INTERNATIONAL STANDARD ISO 3184:1998 TECHNICAL CORRIGENDUM 1

Reach and straddle fork-lift trucks — Stability tests

TECHNICAL CORRIGENDUM 1

Figure 11

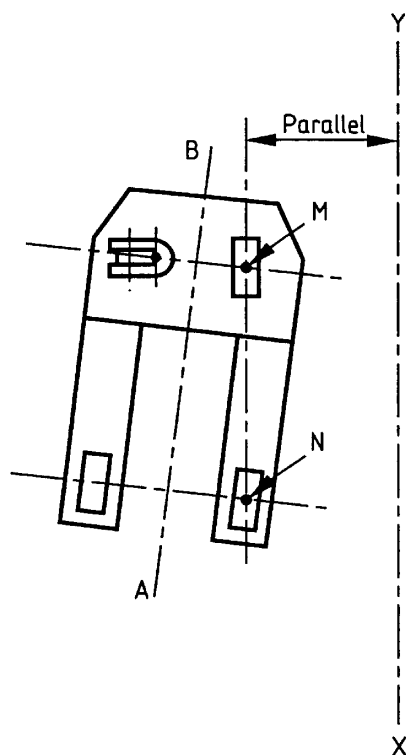
Replace Figures 11, 12 and 16 by the following corrected figures:
